Title: Dielectric grease change

This document will guide the user through understanding why Dielectric grease is different colors on vehicle built after 1/8/2018

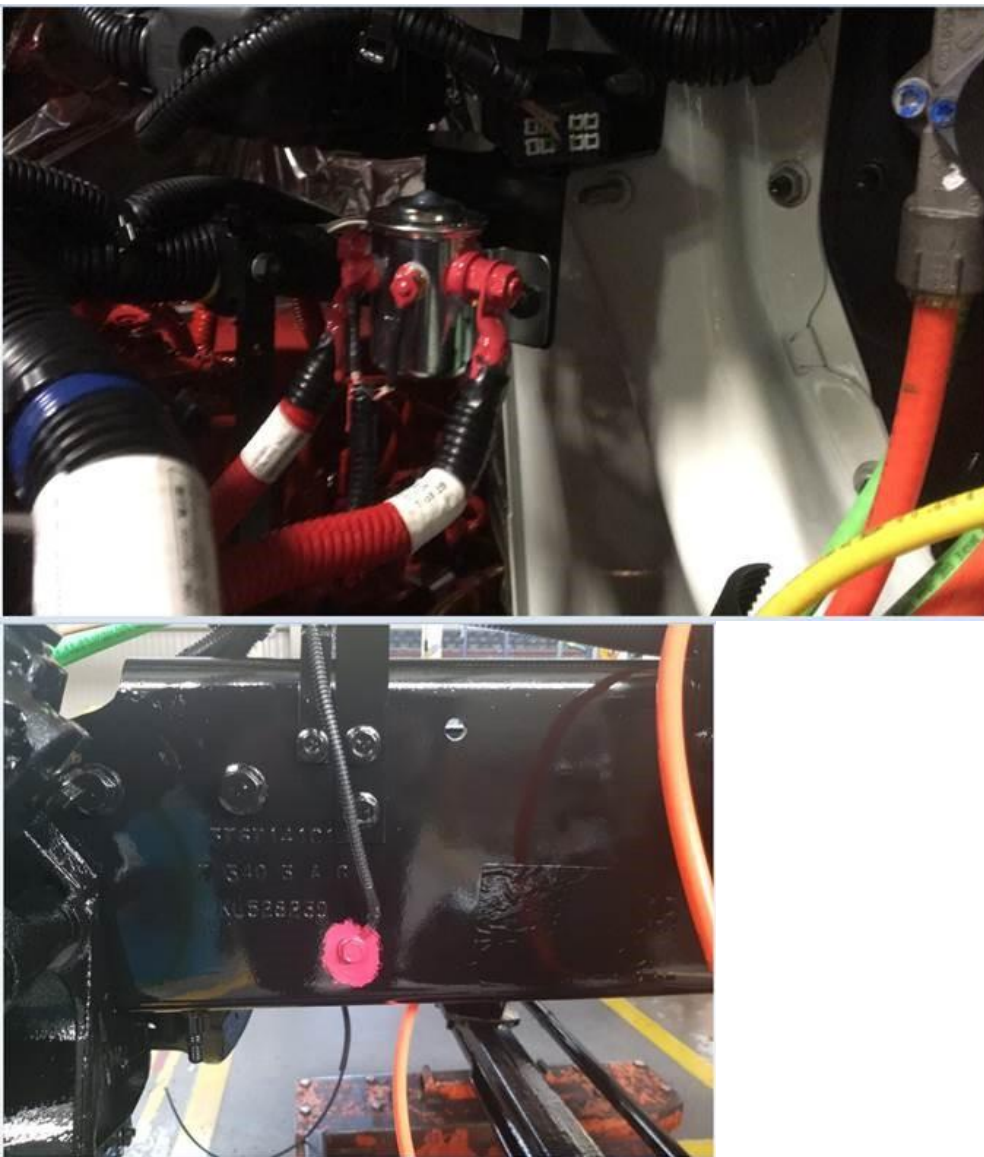
On vehicles built after 1/8/2018 we have changed the type of Dielectric grease used on all major electrical points, please see pictures below for reference. Part numbers will be added once available in PDC.

Battery box interconnections will use **BLUE grease.**

Engine Trim will use **RED** Grease.
